STAFF RECOMMENDATION
2801 27th Avenue South
June 20, 2018

Application: New construction – infill
District: Hillsboro-West End Neighborhood Conservation Zoning Overlay
Council District: 18
Map and Parcel Number: 11703001000
Applicant: Manuel Zeitlin
Project Lead: Melissa Baldock, melissa.baldock@nashville.gov

Description of Project: Application is to construct infill on a vacant lot. The infill contains an attached garage at basement level.

Figures 4 & 5. The site plan (left) for 2805 27th Ave S shows an attached garage at a location wider than the house. The Metro Map (right) shows the existing garage at 2805 27th Ave S, to be demolished, in the same approximate location as the proposed attached garage.

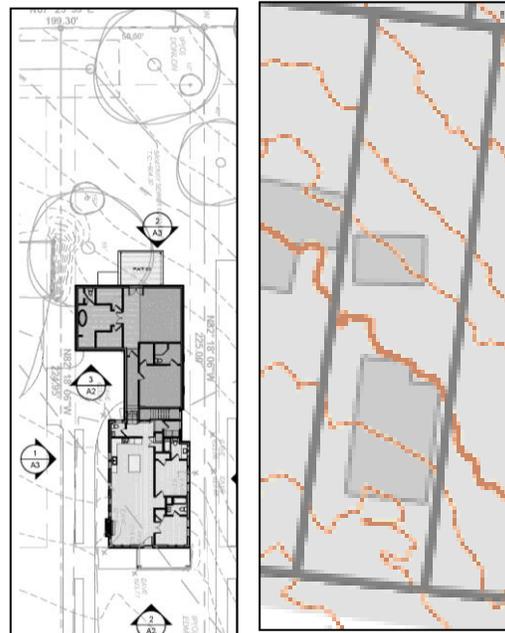
The infill includes an attached garage where the house extends wider. The design guidelines state that attached garages can be appropriate when they are located at the basement level and when they are located in areas where an outbuilding would have been historically. In this case, the garage is located at the basement level. Since this lot lacks an alley, historically an outbuilding would have had garage doors facing the street and would have been located to the side of the historic house. MHZC approved a similar configuration in the addition next door at 2805 27th Avenue South (Figure 4). In that case, the Commission found that an existing outbuilding, which was to be demolished, was located in the approximate area as the proposed attached garage (Figures 5). From the street, the attached garages for 2801 and 2805 27th Avenue South will have more of an appearance of a separate garage structure. Staff finds that the proposed attached garage meets Section II.B.1.h. of the design guidelines.

① SITE PLAN
1" = 20'-0"

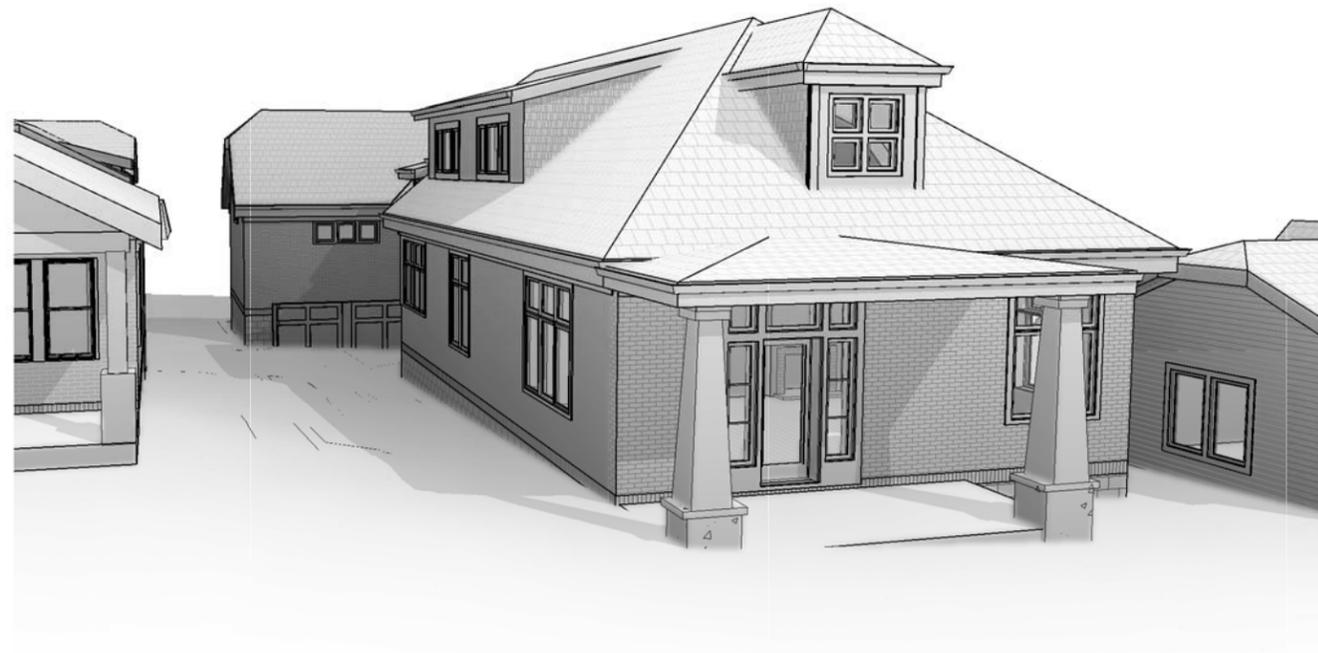
Orientation: The infill will be oriented towards 27th Avenue South, which is appropriate. It includes an eight foot (8') deep, partial-width front porch. No walkway was included on the site plan, and staff recommends the inclusion of a walkway leading from the street to the front porch.

The site has no alley, so vehicular access will be via a driveway to the left side of the property. The driveway will have concrete strips and will be eleven feet (11') wide, which is appropriate. Staff finds that the infill's orientation meets Section II.B.1.f. of the design guidelines.

Appurtenances & Utilities: A new driveway will be added on the left side of the property, as the site lacks alley access. The driveway will be eleven feet (11') wide with concrete strips, which staff finds to be appropriate. Staff recommends the addition of a walkway from the street to the front porch. The location of the HVAC and other utilities was not noted. Staff recommends that the HVAC be located on the rear façade, or on a side façade beyond the midpoint of the house. With the staff's approval of the HVAC location and the inclusion of a front walkway, staff finds that the proposed appurtenances and utilities meet Section II.B.1. i. of the design guidelines.

2801 27TH AVENUE
HISTORIC SUBMITTAL
ELEVATIONS

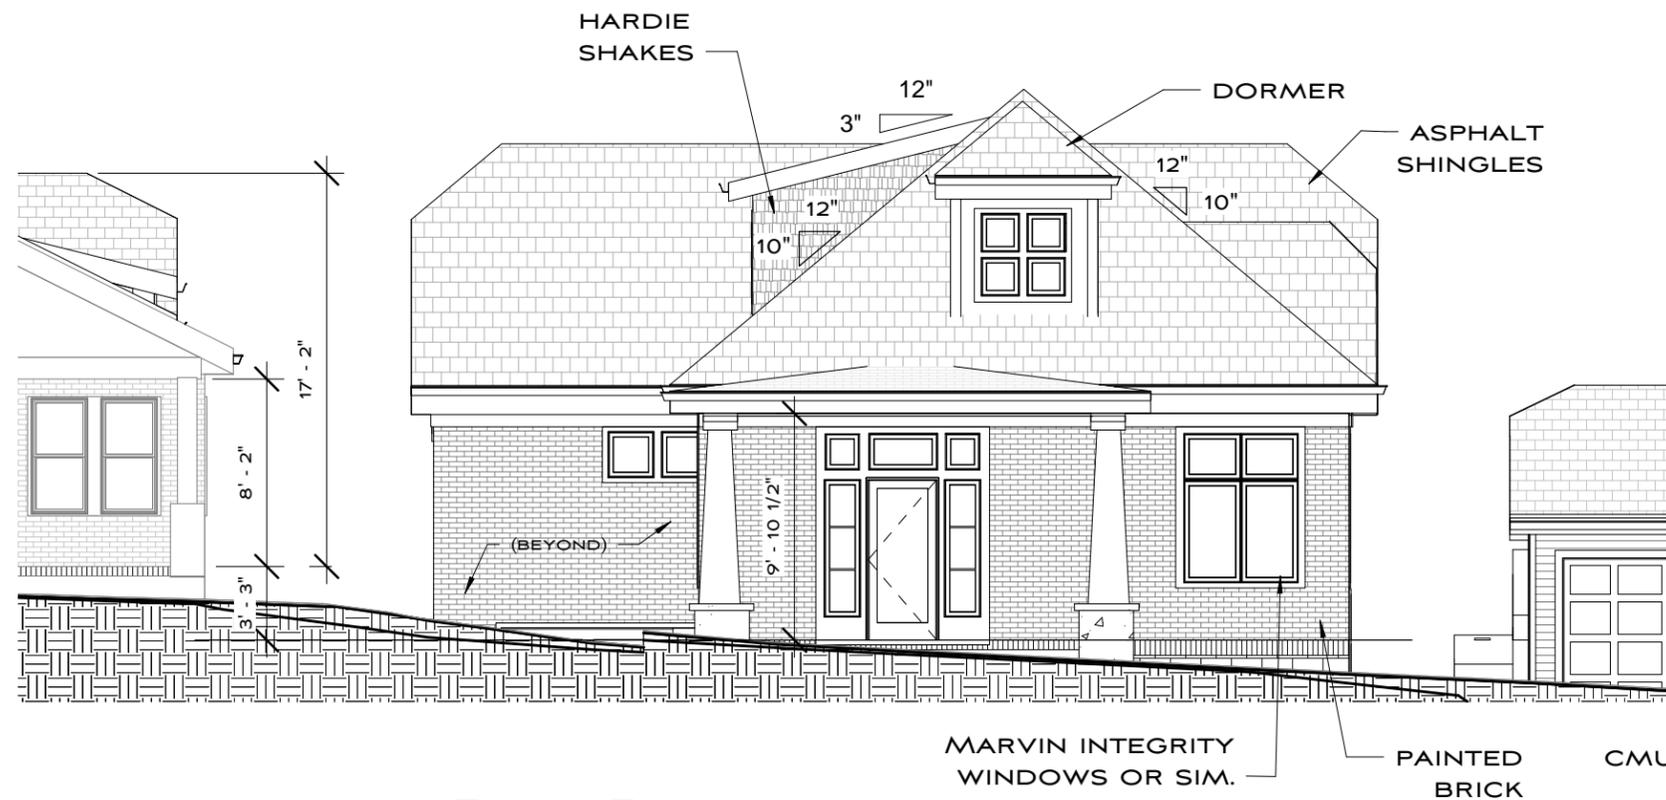
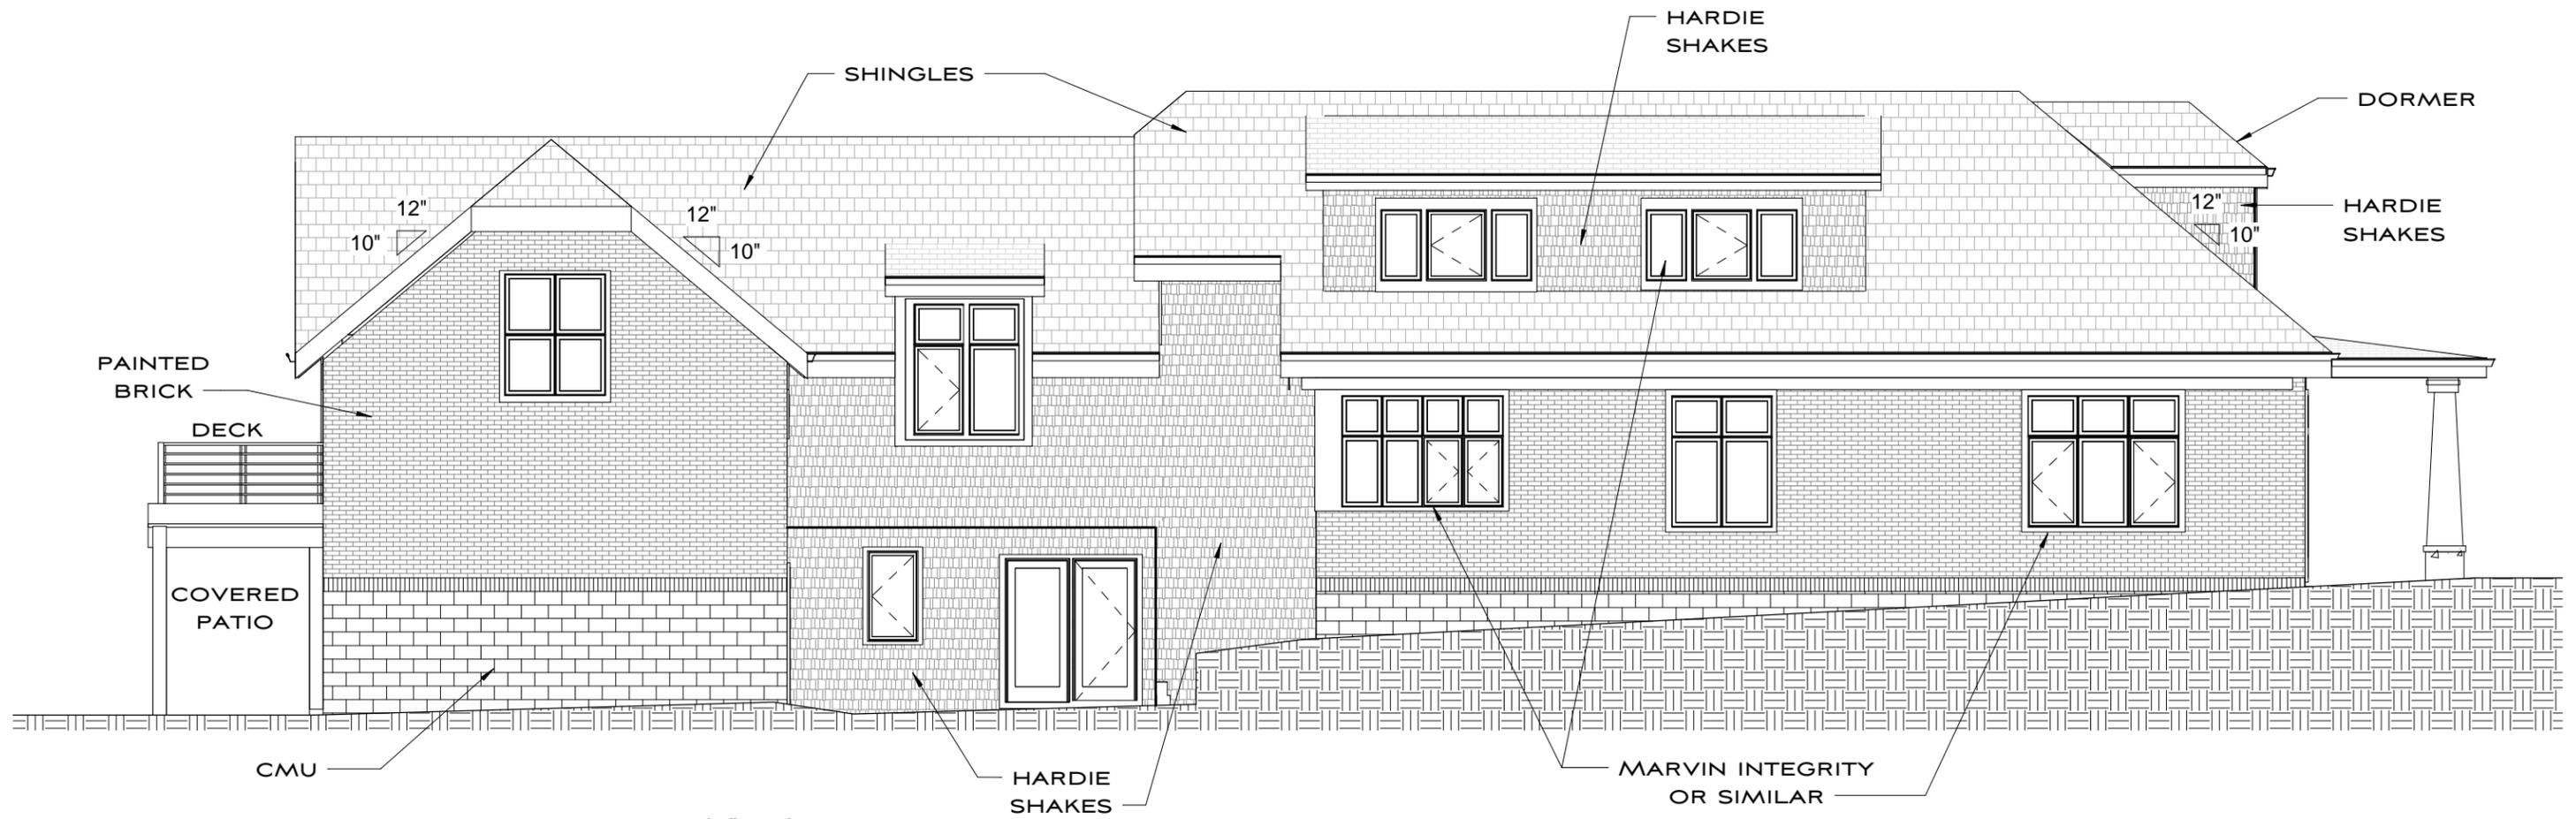
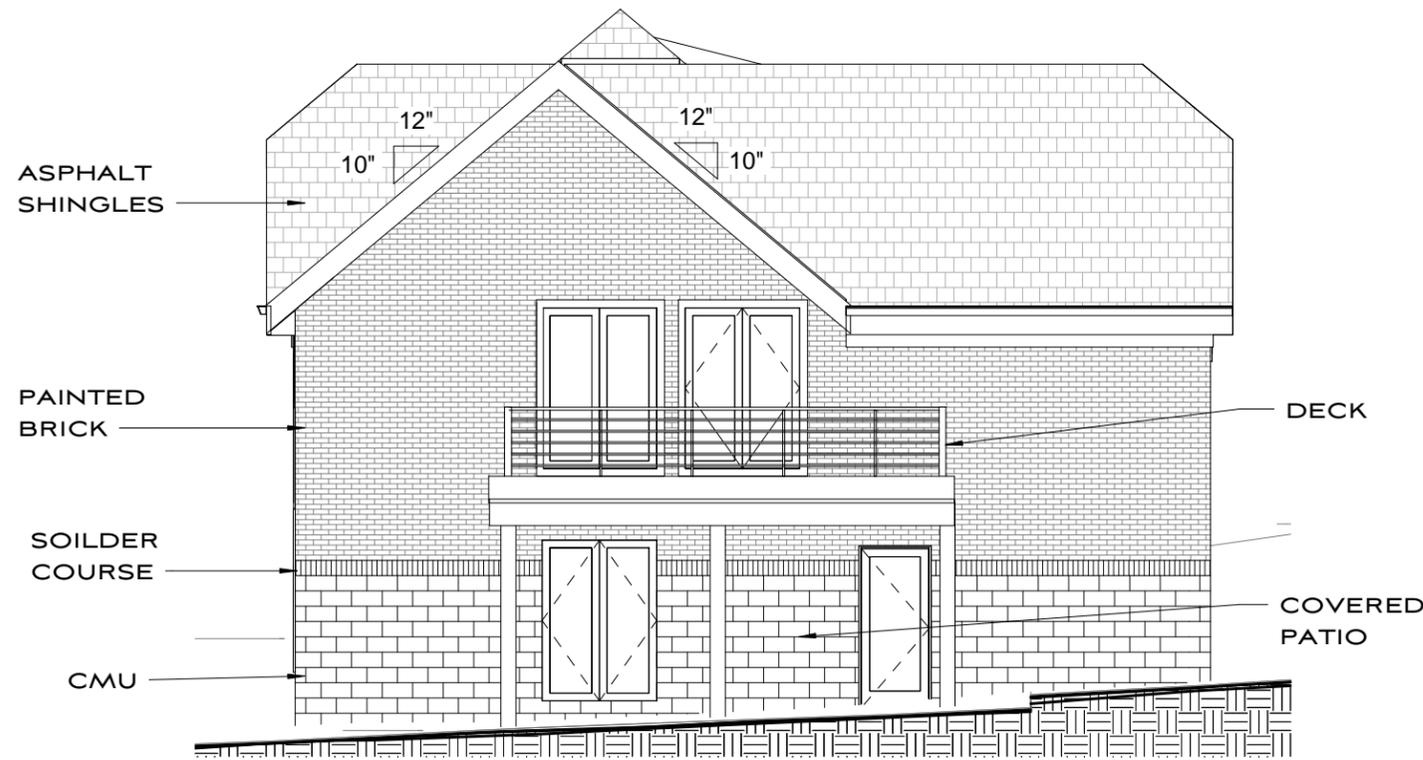
Height & Scale: The proposed infill is one-and-a-half-stories in height at the front. It has an eave height of approximately ten feet (10') at the front from the foundation line and a ridge height of approximately twenty-four feet, six inches (24' 6") from the foundation line. Staff finds that the infill's height meets the historic context where houses range in height from nineteen and twenty-eight feet (19'-28') in height.

The site slopes towards the back so that at the rear there is an occupied basement level. The foundation height is shown as minimal at the front and gets taller further back on the site because of the slope. Staff recommends approval of the foundation height and first floor framing height in the field to ensure that the foundation and floor heights are compatible with the immediate historic context.

Proportion and Rhythm of Openings: The windows on the proposed infill are largely twice as tall as they are wide, thereby meeting the historic proportions of openings. On the right elevation, there is a wall space of approximately twenty feet (20') without a window or door opening. Staff finds this expanse to be appropriate because it located at a point over forty-feet (40') from the front of the house and over seventy-feet (70') from the street. The expanse of wall space will not be highly visible from the street. Staff recommends that all double window openings have a four to six inch (4"-6") mullion in between them. With the condition that all double window openings have a four to six inch (4"-6") mullion in between them, staff finds the project's proportion and rhythm of openings to meet Section II.B.1.g. of the design guidelines.

1. The finished floor height shall be consistent with the finished floor heights of the adjacent historic houses, to be verified by MHZC staff in the field;
2. Staff approve the final details, dimensions and materials of windows and doors prior to purchase and installation;
3. Staff approve a brick sample;
4. Staff approve a stone sample;
5. The concrete block foundation be split face;
6. Staff approve the material of the front porch floor and steps;
7. Staff approve the roof shingle color, material, and texture;
8. A walkway be included from the street to the front porch, and staff approve the walkway material;
9. All double window openings have a four to six inch (4"-6") mullion in between them; and
10. The HVAC be located behind the house or on either side, beyond the mid-point of the house.

2801 27TH AVENUE
 HISTORIC SUBMITTAL
 ROOF PLAN

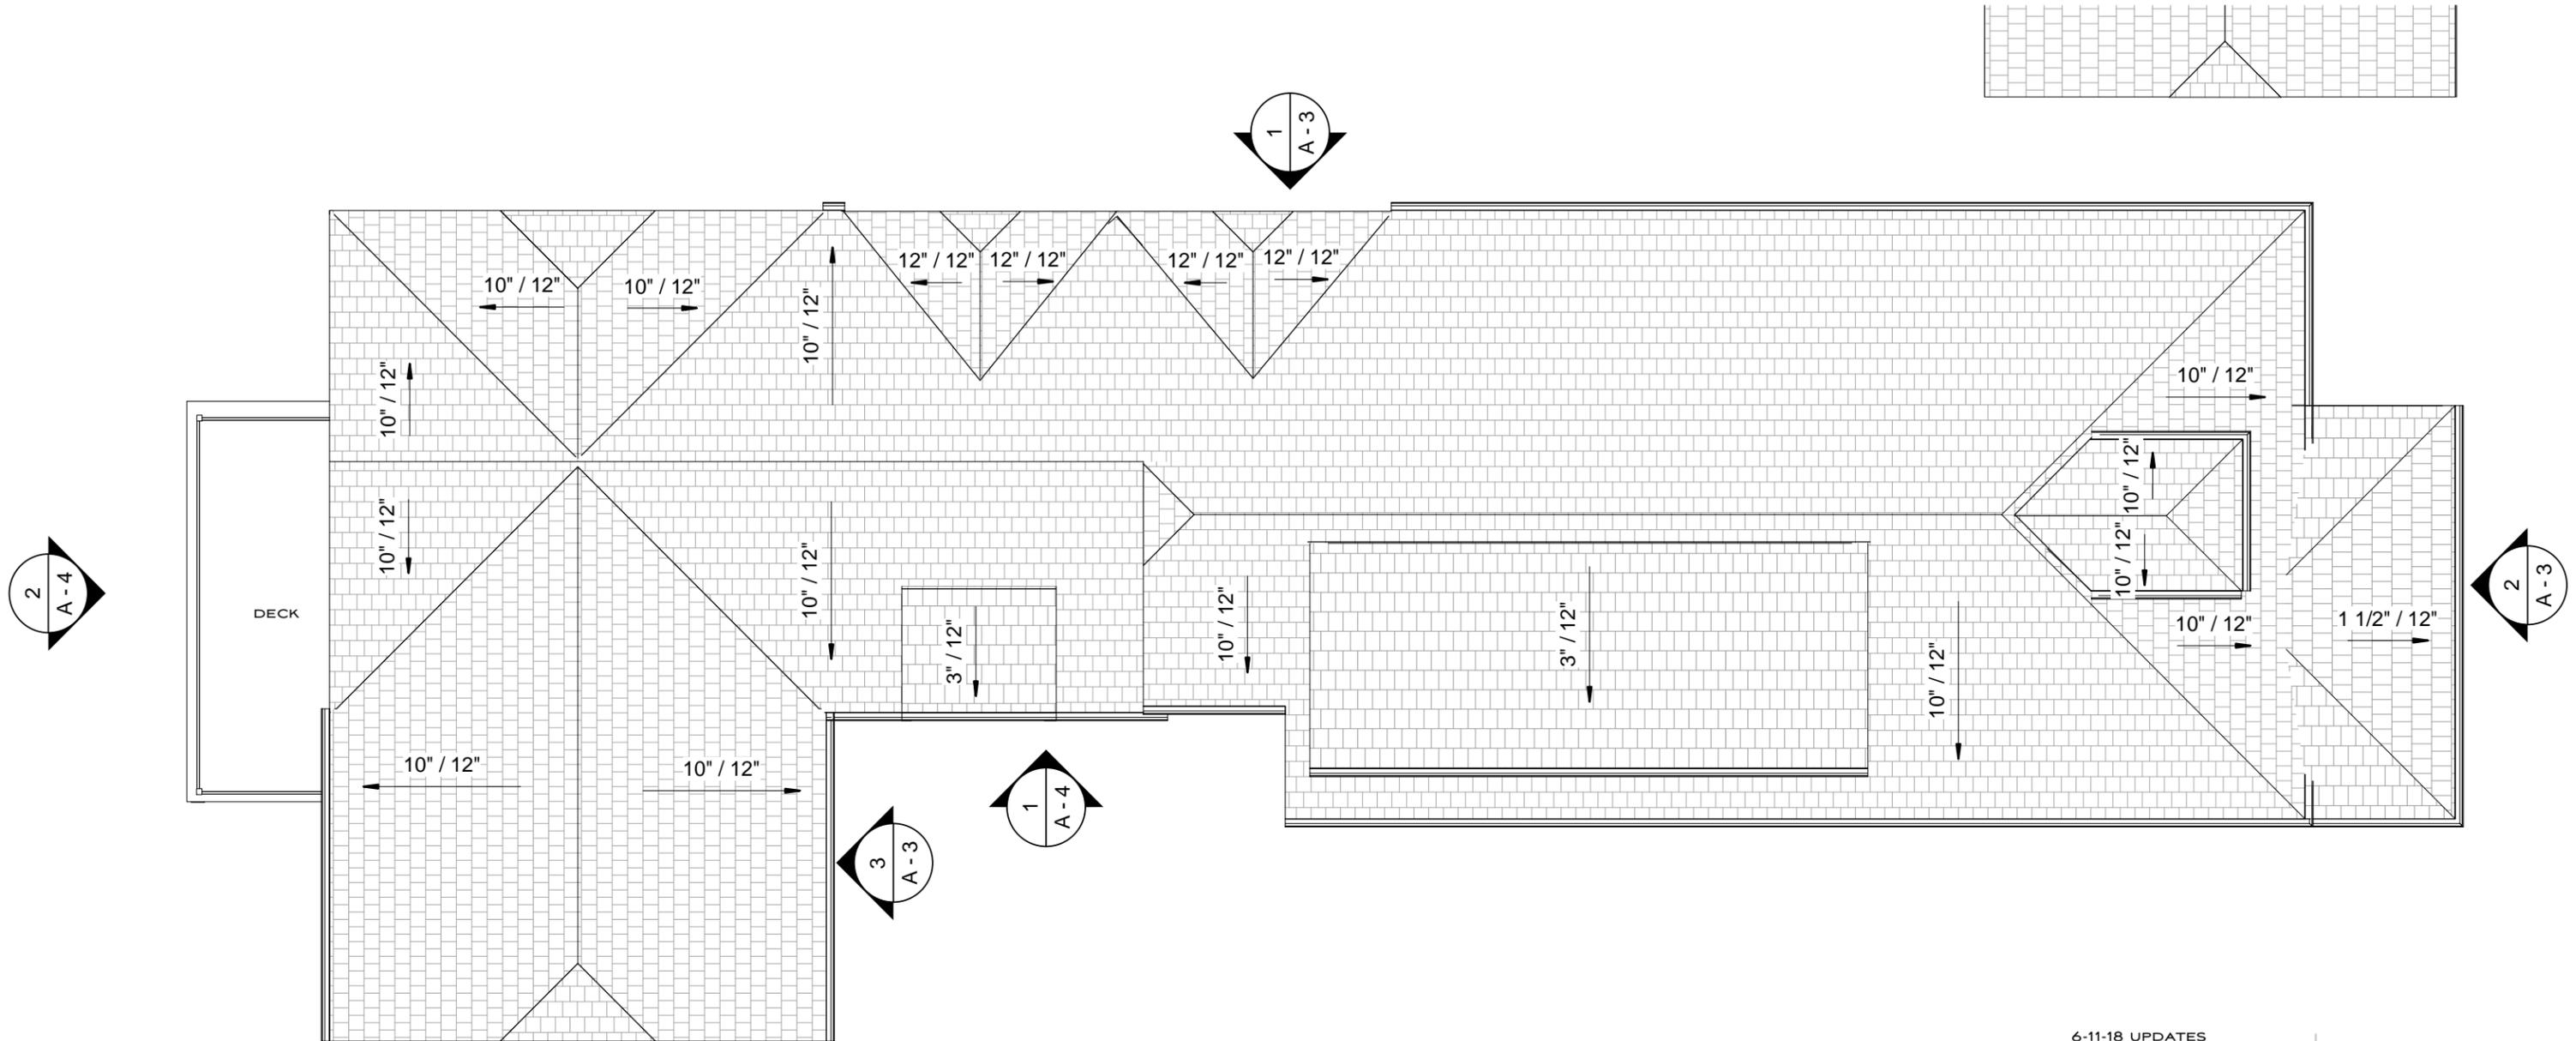
Roof form: The house’s primary roof form is a hip with a 10/12 slope. This is similar to the roof of the historic house next door at 2805 27th Avenue South. The porch roof will also be hipped with a 2/12 slope. The front dormer will also be hipped with a 10/12 slope, while the side shed dormer will have a 3/12 pitch. The wider portion of the infill will have a clipped gable form with a 10/12 slope. The left elevation contains a wall dormer, which is not typically approved. Staff, however, finds this wall dormer to be acceptable, in this instance, because it is on a part of the house that is inset approximately thirteen feet (13’) from the main side wall of the house. It will not be highly visible from the street. The right elevation contains cross gable forms with 10/12 and 12/12 pitches, and staff finds these to meet the design guidelines. Staff finds that the proposed roof forms meet Section II.B.1.e. of the design guidelines.
